Pecos Street over I-70 Bridge Replacement

Value Engineering Study

Prepared for CDOT Region 6
Project Number: FBR 0704-224 (18149)
February 15, 2012

Red hatched area depicts limits of reinforced pavement

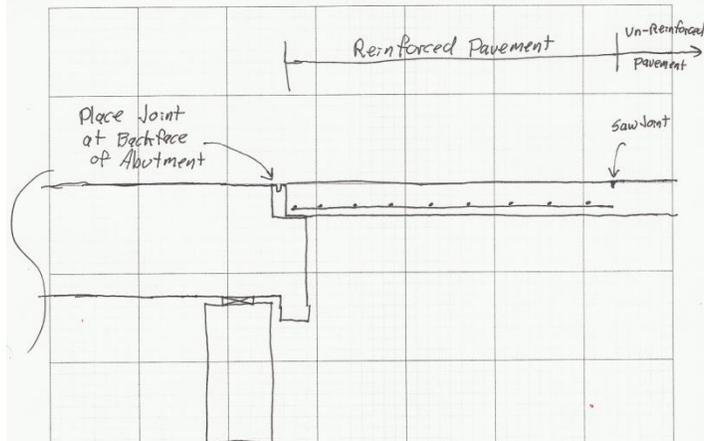
Due to the proximity of the bridge to both roundabouts, particularly the south one, construction of a traditional 20' long approach slab places the expansion joint and underlying sleeper slab in undesirable locations. At the south end, the expansion joint would fall within the limits of the roundabout and truck apron, and cross at an extreme skew. The north joint location is outside the roundabout pavement, but falls within a wide area of pavement and creates the need for a skewed joint angle.

This VE proposal recommends that the traditional approach slab be omitted, and as an alternate the section of pavement adjacent to the bridge reinforced as shown in the sketch at right. The expansion joint would be located at the end of the bridge, and the reinforced pavement section would rest on a paving lug on the abutment backwall.

Value Engineering Proposal No. 2
Change Bridge Foundation Type
Recommended Action: Incorporate

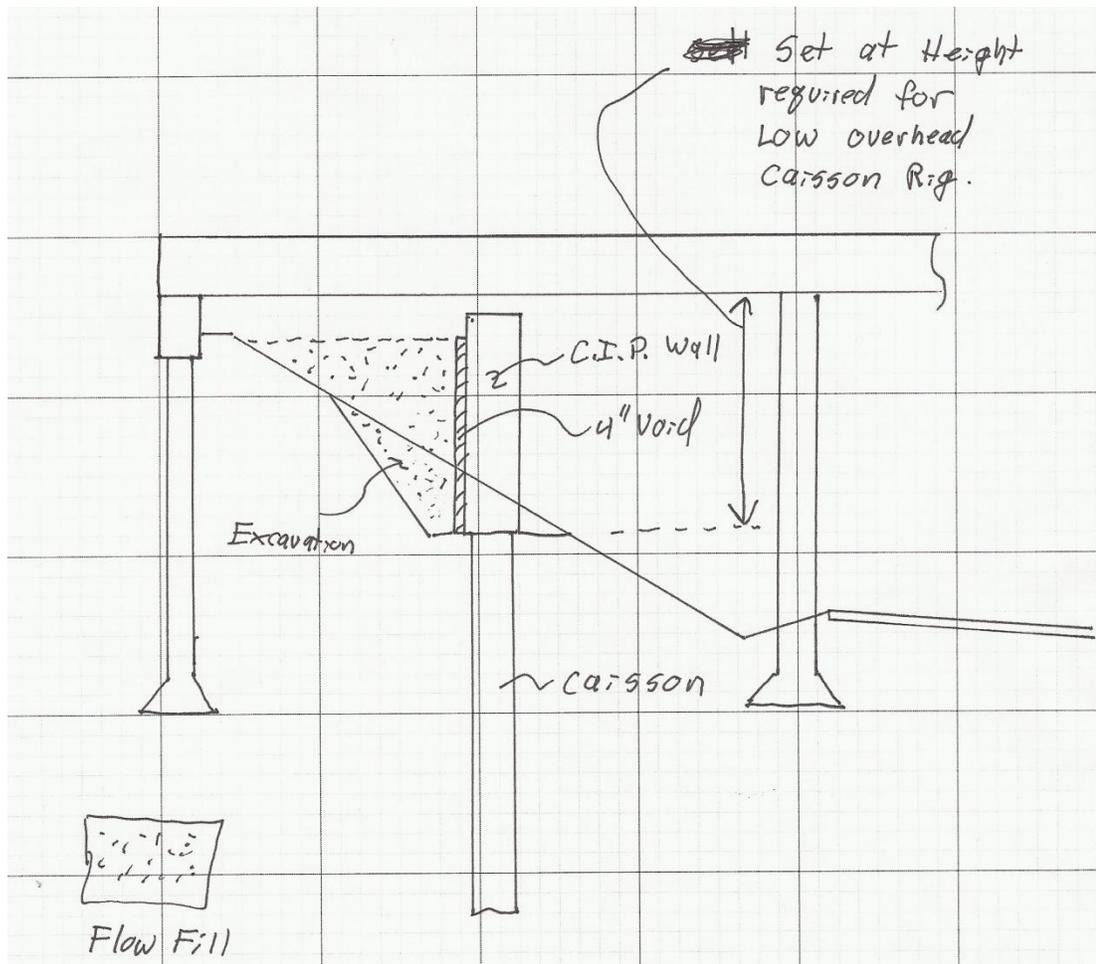
Summary: Instead of the current spread footing and abutment stem wall foundation, use a series of drilled shafts topped by a cast in place or precast abutment wall.

The current design calls for spread footings constructed on shallow bedrock that is roughly just below the existing ditch elevation along I-70. The amount and depth of excavation necessary for construction of the spread footing will require the installation of a soil nail wall to stabilize the slope.

This VE proposal would substitute a series of drilled shafts topped by either a cast in place or precast abutment beam. Using a low headroom (8') drill rig, the depth and amount of excavation necessary for construction of the spread footing will require the installation of a soil nail wall to stabilize the slope.

Value Engineering Proposal No. 7
Close 48th Avenue During Construction
Recommended Action: Incorporate

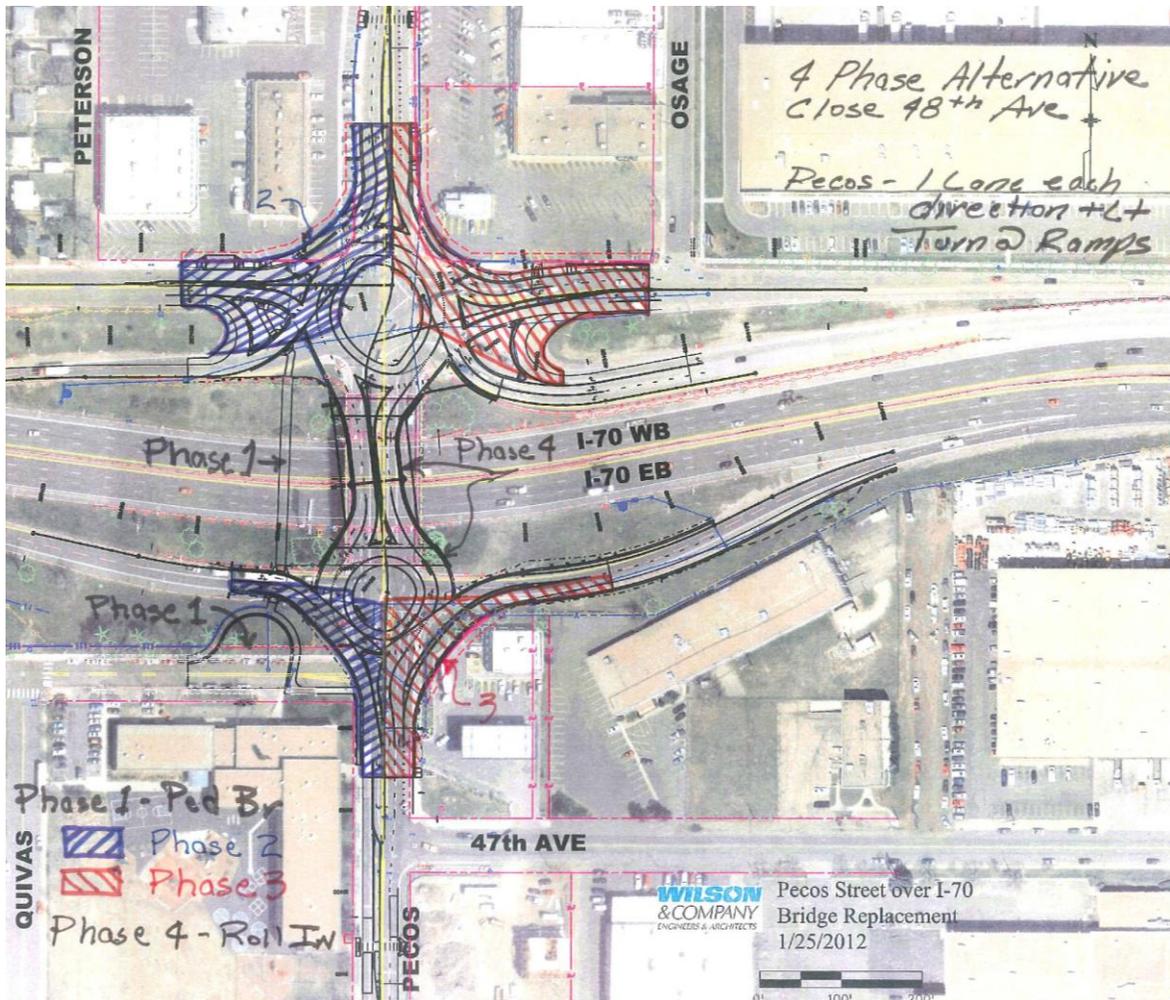
Summary: Allow the short term closure of 48th Avenue in conjunction with construction of the project.

Allowing the full closure of 48th Avenue reduces the number of construction phases anticipated for the project by 2 and shortens the estimated construction duration by 21 calendar days. A sketch outlining the limits of construction for the phases necessary to complete the ramps and 48th Avenue is shown below. These are rough construction limits only, and would need to be refined to determine actual limits based on jointing plans, etc. The intent is to close and construct the hatched area, while keeping ramp traffic active. When I-70 is closed for the bridge roll in, the ramp pavement and the remainder of the roundabout would be completed.

4 Phase Alternative
Close 48th Ave

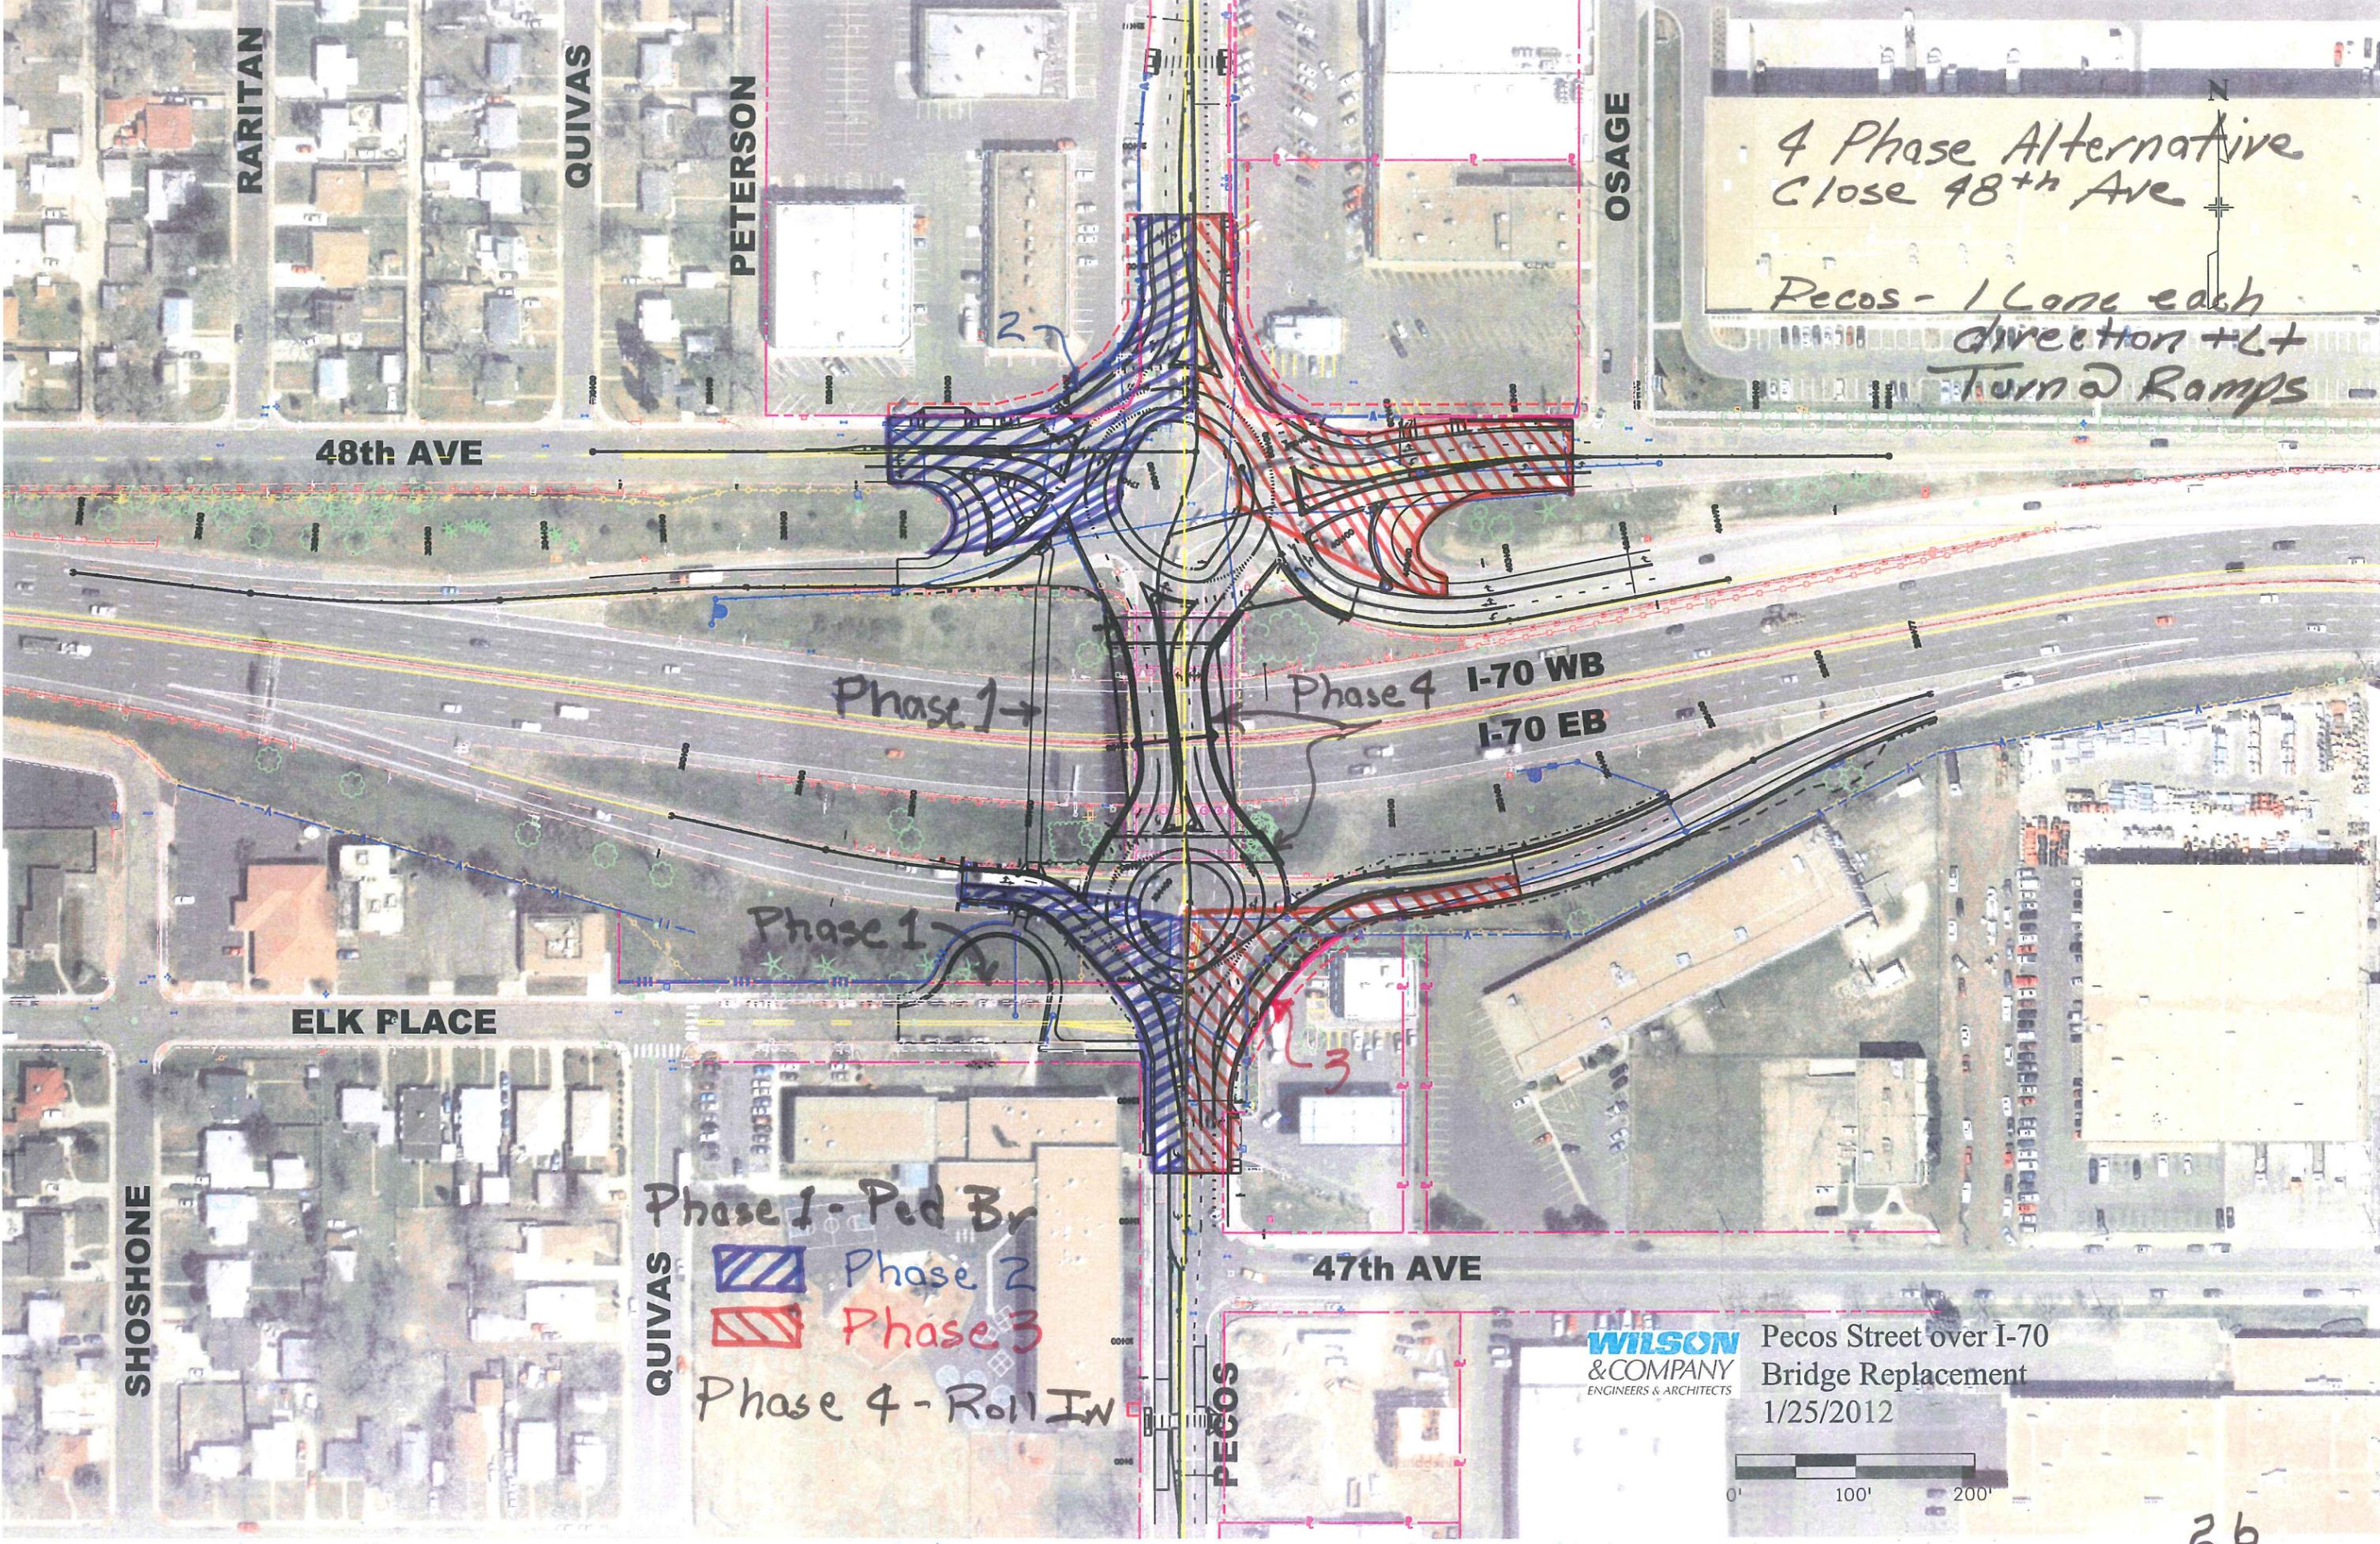
A reduction in the number of traffic lanes on Pecos would be required to accommodate this phasing plan. It was assumed traffic could be reduced to one lane in each direction with a dedicated left turn lane for the WB and EB on ramps. A right turn lane or taper would be provided for the ramps where there was adequate room.

6 Phase Alternative
Keep 48th Open

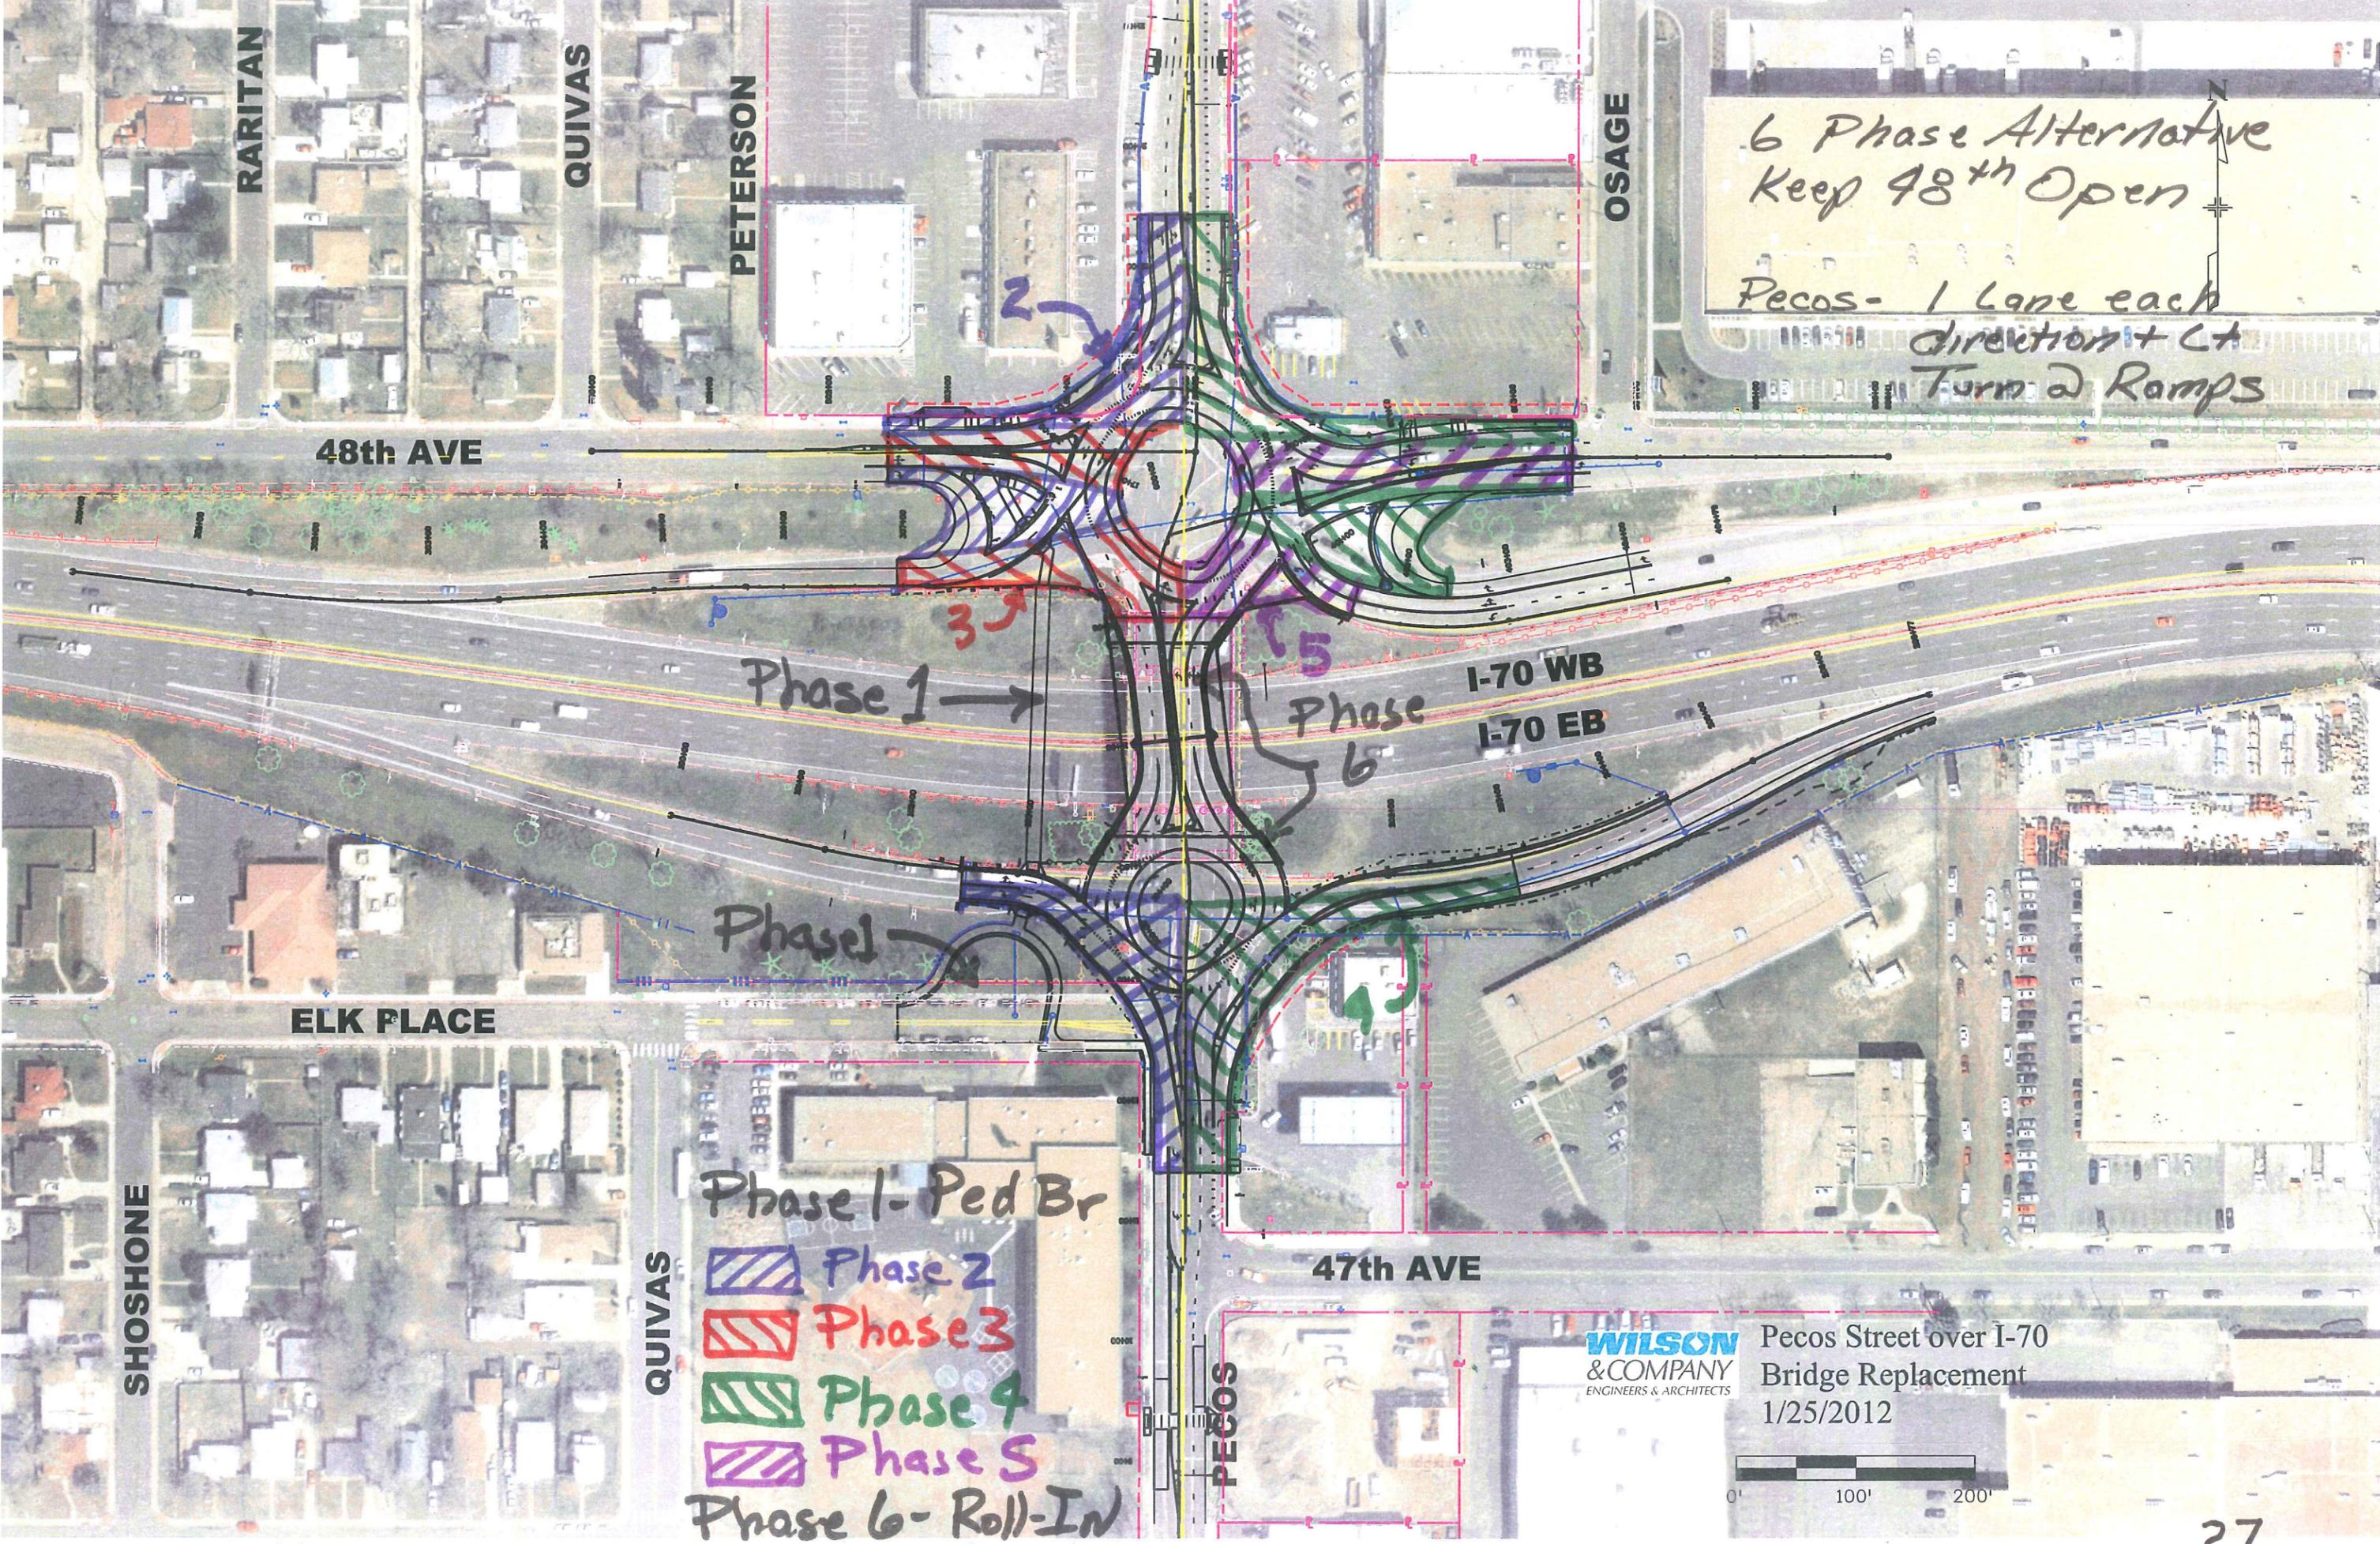
A variety of construction phasing scenarios were developed, ranging from complete closure of Pecos Street for a short duration, to 3-lane and 4-lane configurations, with and without the closure of 48th Avenue. The estimated construction duration for each alternative was developed, and the associated user delay costs tabulated for each scenario. Schematic layouts depicting the various phases of construction for providing 3 lanes on Pecos are included on the following pages. A schematic for the full closure of Pecos was not developed, nor one showing the additional phases that would be needed to provide 4 lanes during construction.
